**CEDAR CREEK STREAM AND WETLAND RESTORATION  
PROJECT  
MONITORING REPORT  
MONITORING YEAR 3  
FINAL**

SAMPSON COUNTY, NORTH CAROLINA  
CONTRACT No. 005011 - PROJECT No. 95718  
USACE ACTION ID No. 2012-00389 – NCDWR PROJECT No. 2013-0186

RE: Cedar Creek Stream and Wetland Restoration Site: MY3 Monitoring Report  
(NCDMS ID 95718)

Listed below are comments provided by DMS on January 31, 2018 regarding the Cedar Creek Stream and Wetland Restoration Site: Year 3 Monitoring Report and RES' responses.

- ▬ Conservation Easement
  - Vegetation Plots
  - ▬ Cross Sections
  - Crest Gauge
  - ▬ Top of Bank
  - ▬ Enhancement I
  - ▬ Enhancement II
  - ▬ Headwater Valley Restoration
  - ▬ P1 Restoration
  - ▬ Wetland Restoration Area
- Well Hydroperiod**
- ⊕ >9%
  - ⊕ <9%

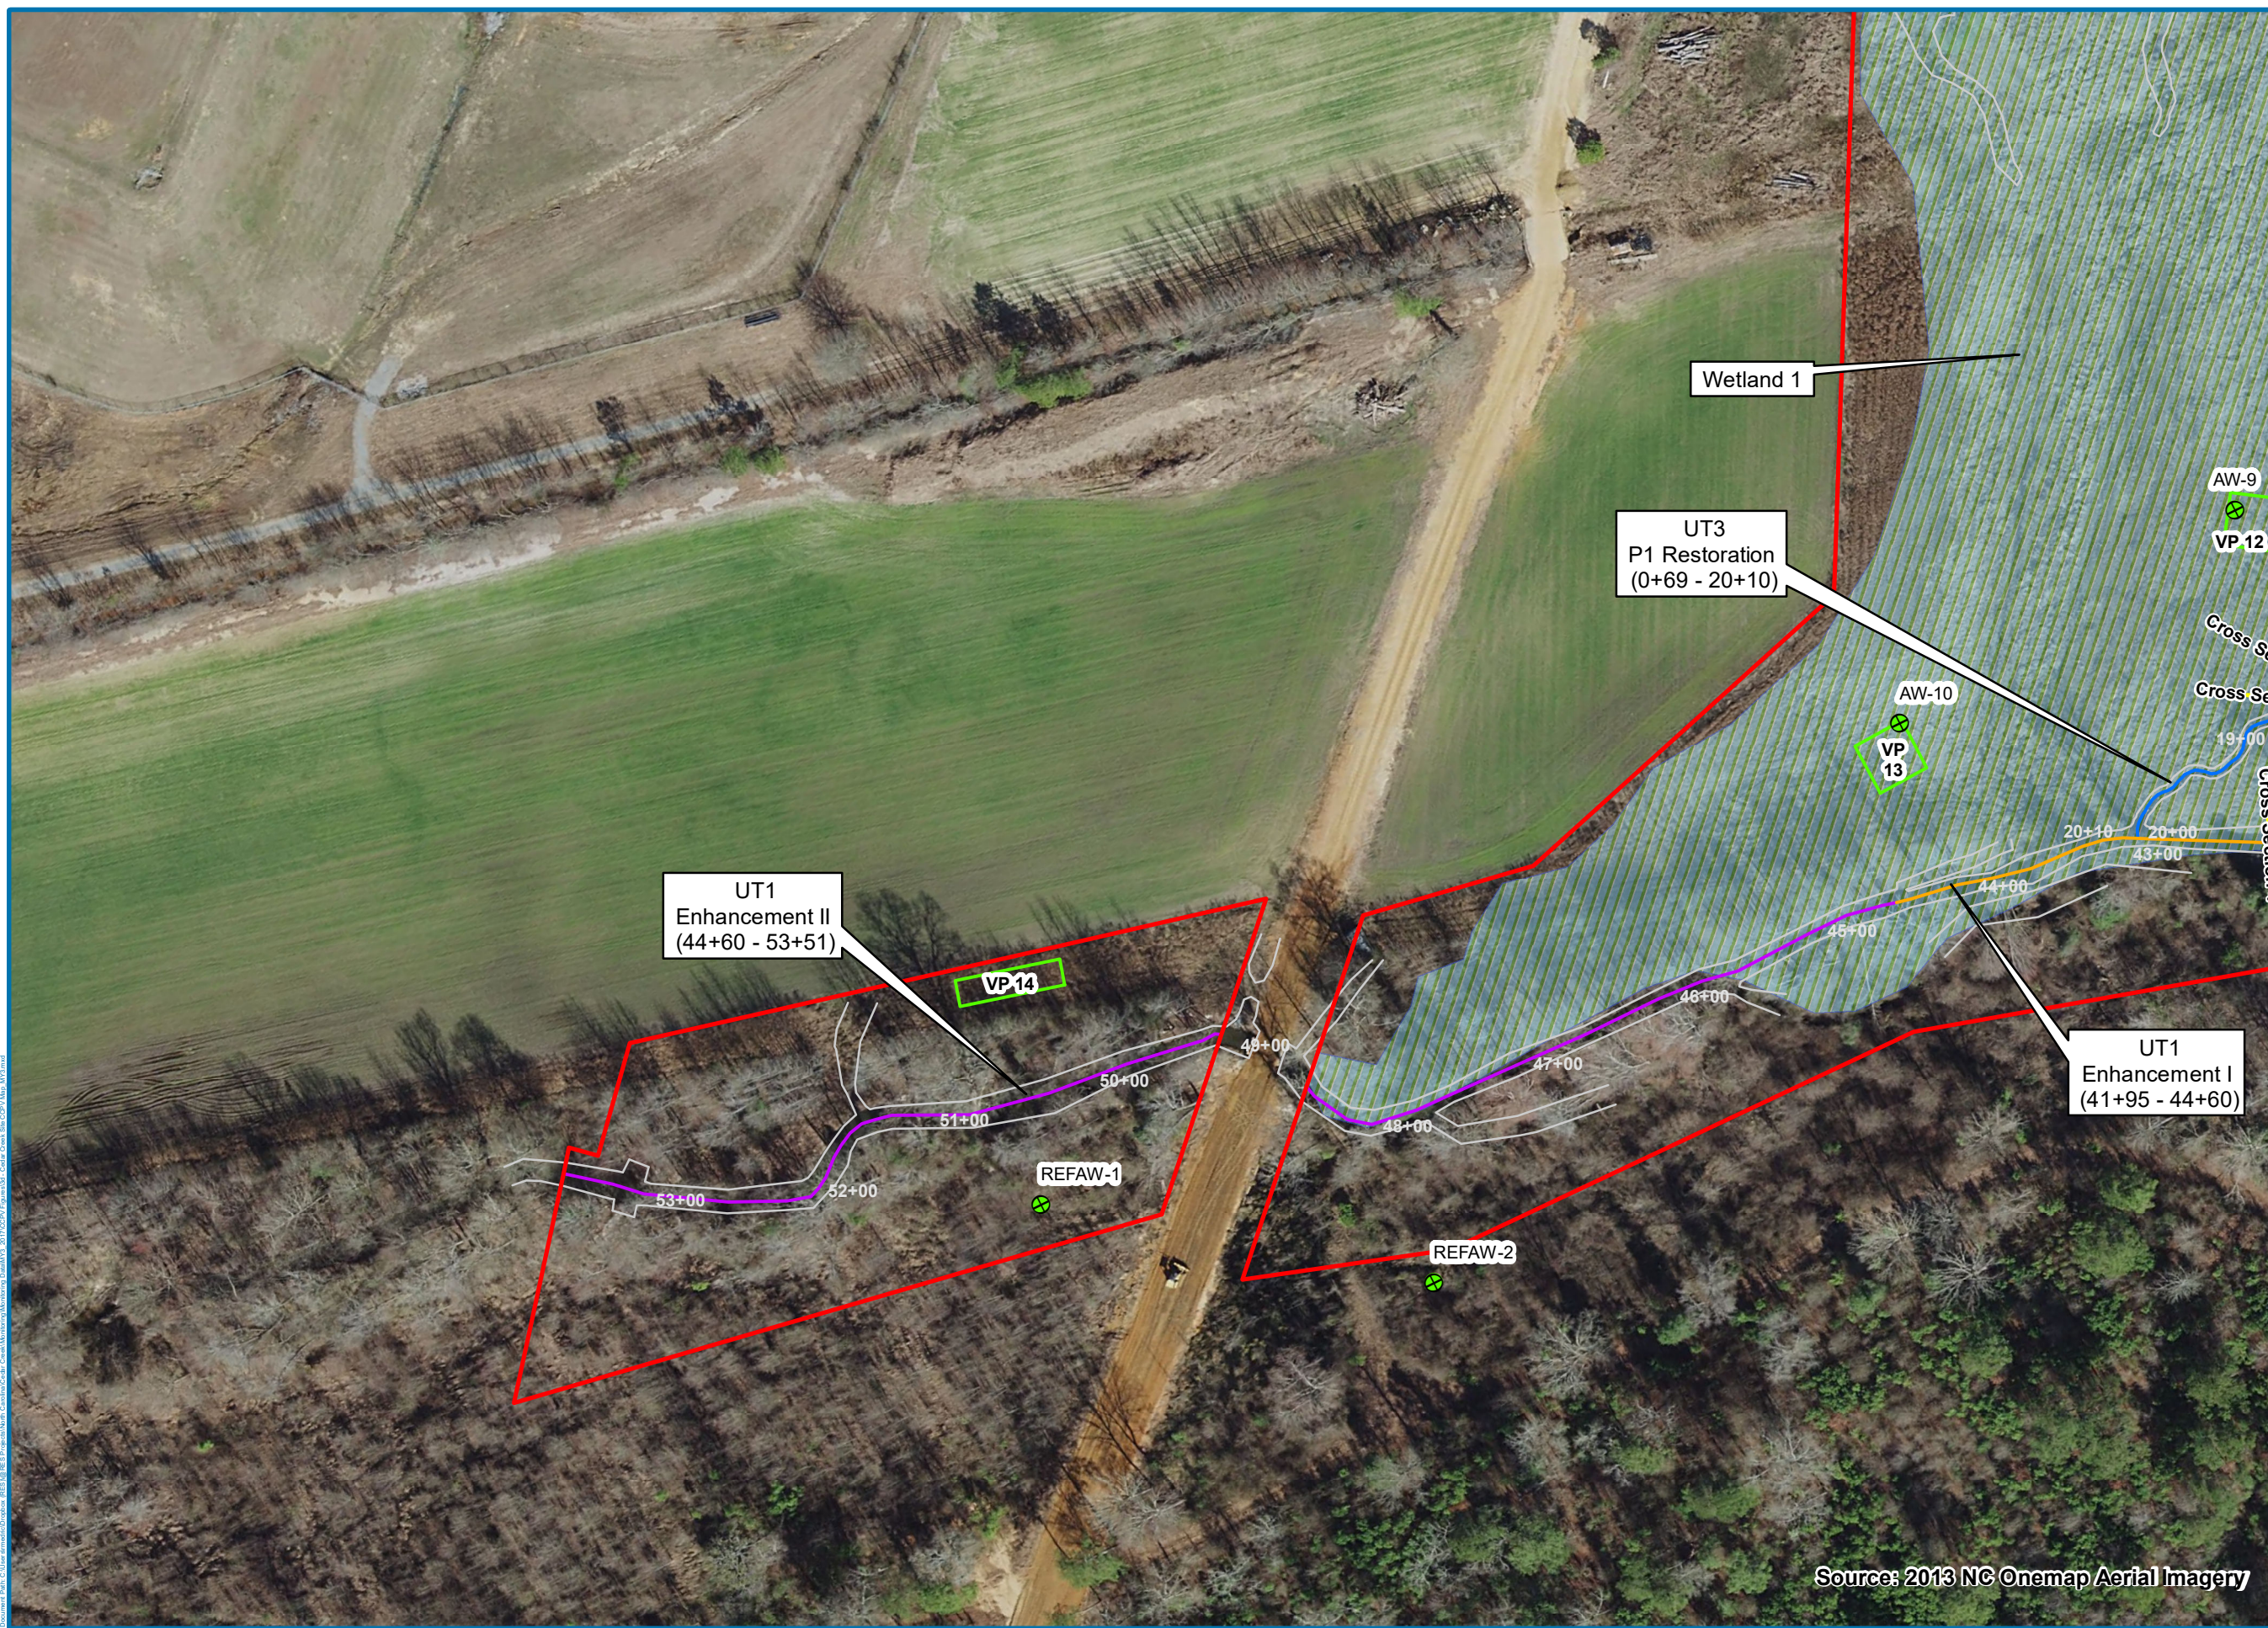
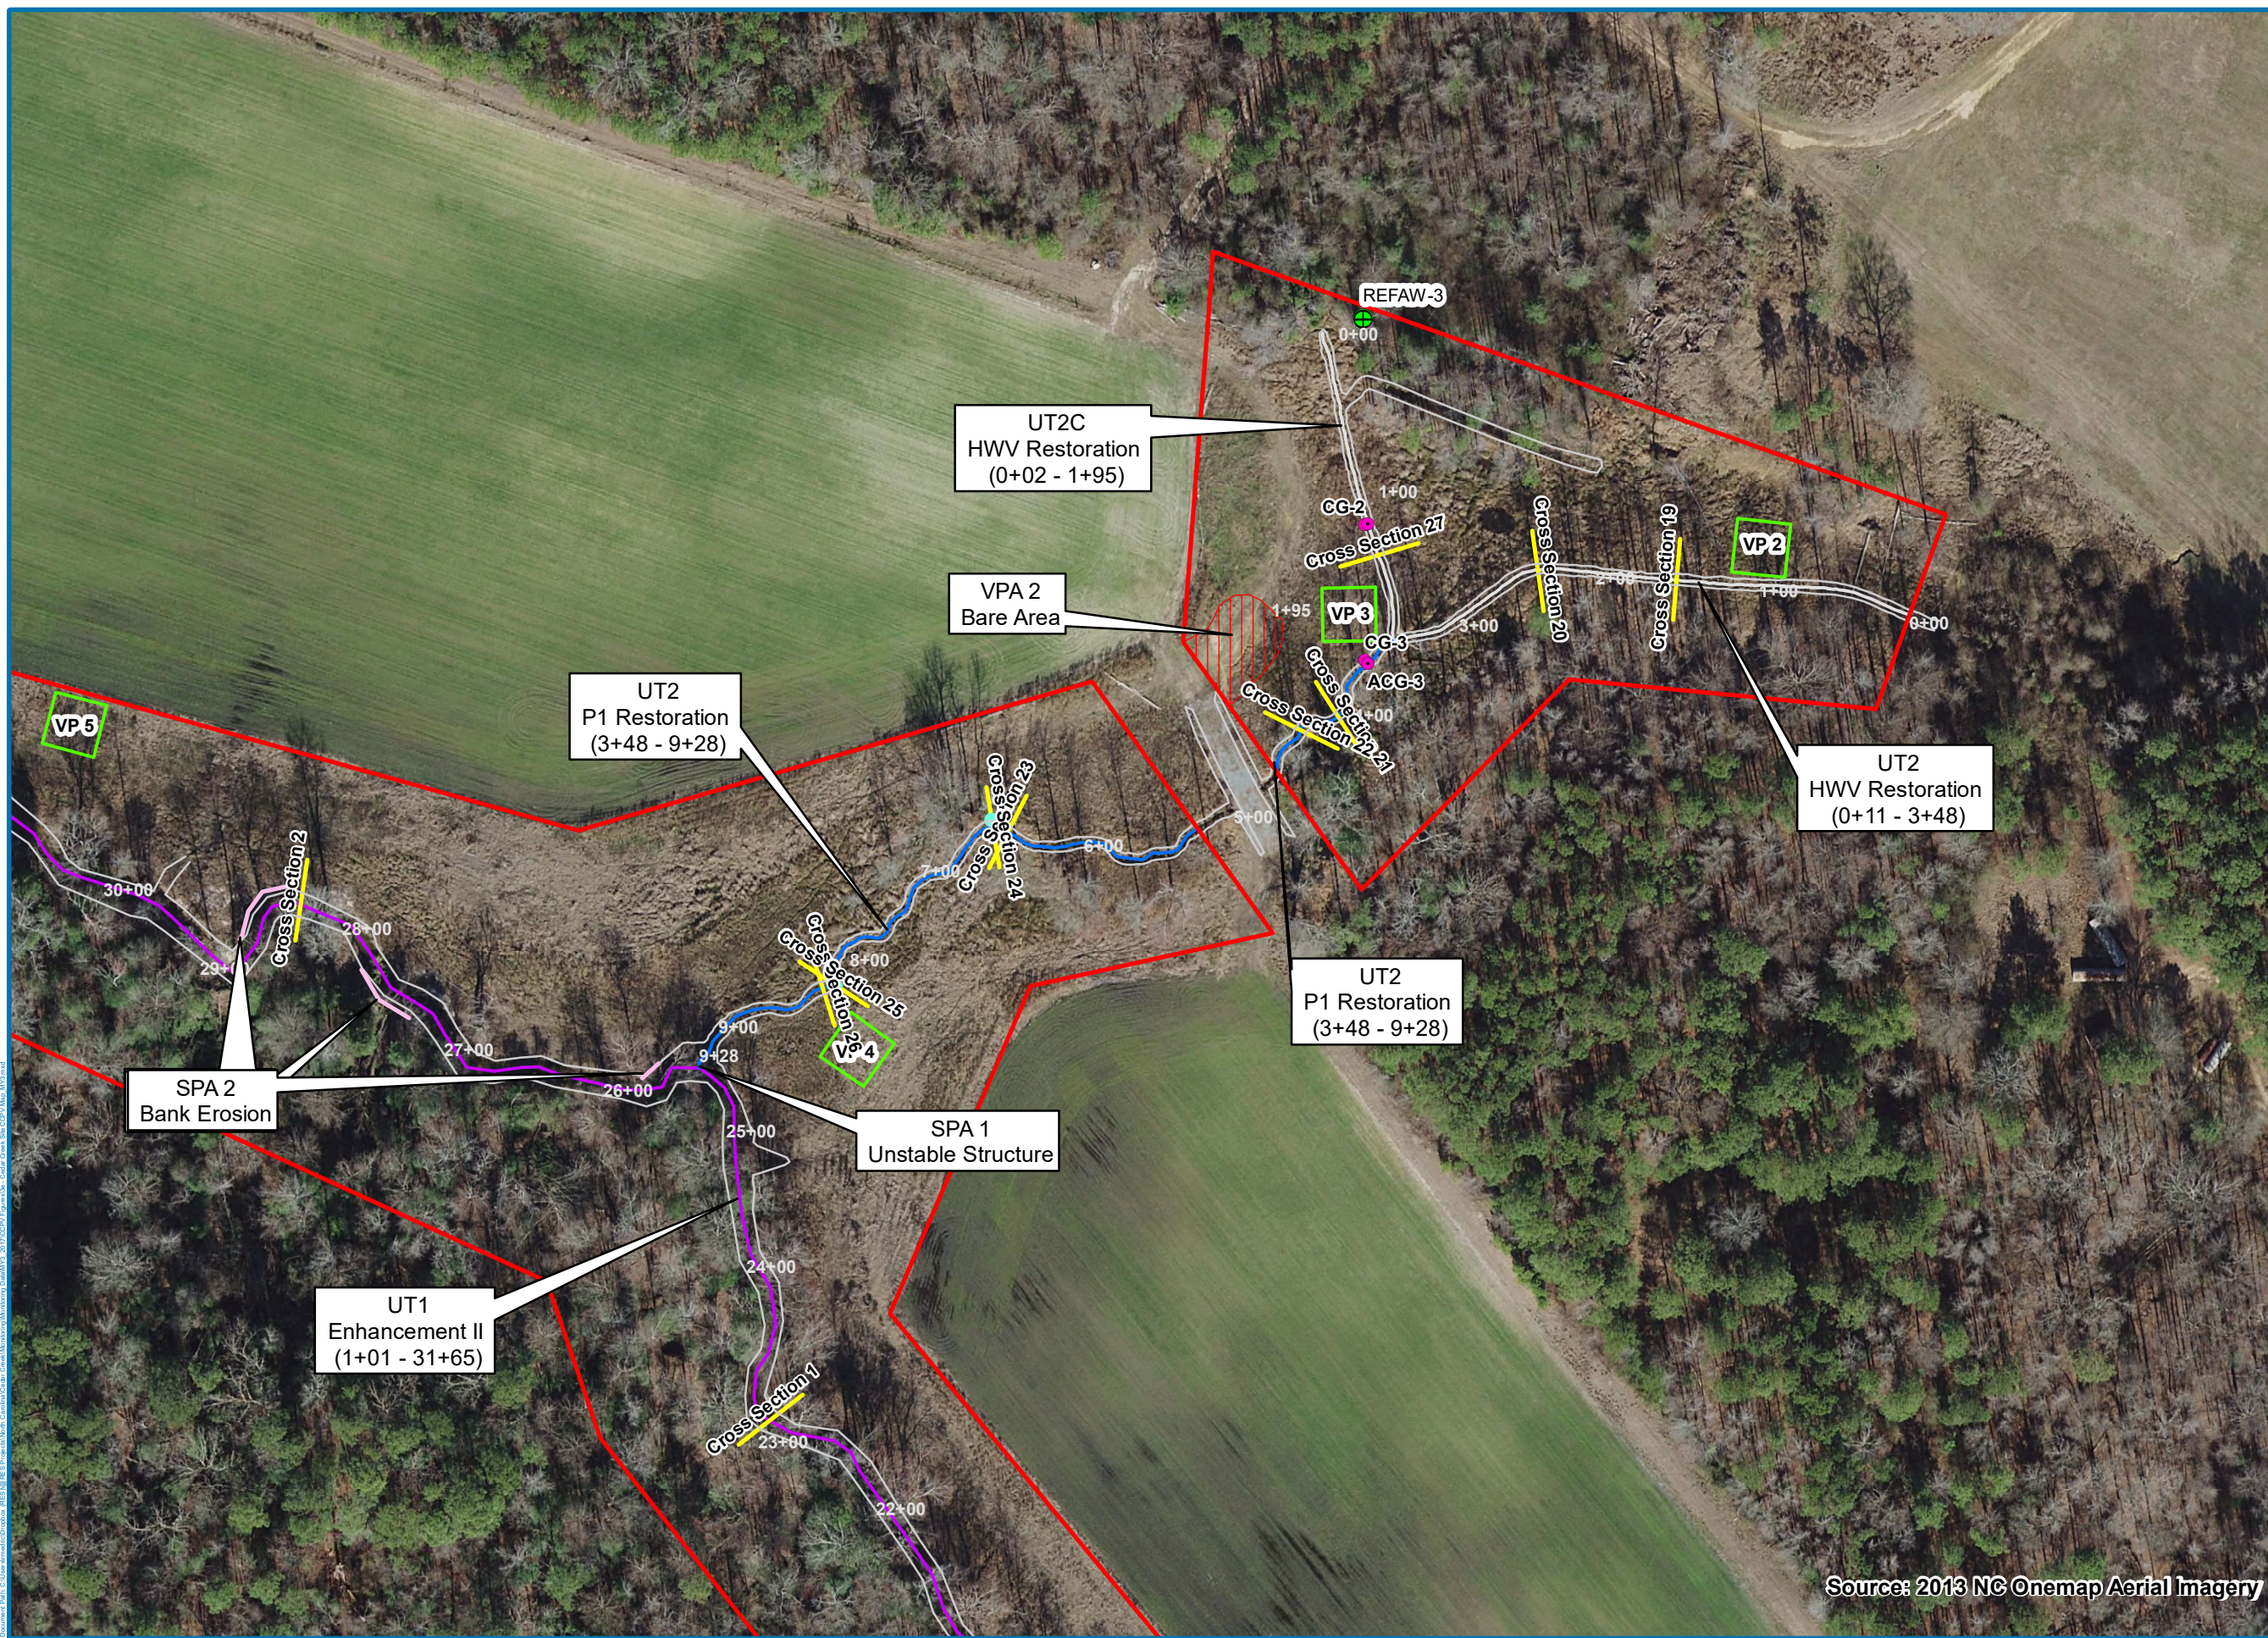
Appendix B, CCPV:

a. Figures 3a through 3f: Use consistent symbology in the Legends for each figure.

b. If there are four SPAs, show SPA4 on the appropriate figure.

c. The locations of bank pins are not shown. Please show on appropriate figure(s).

[Done.](#)
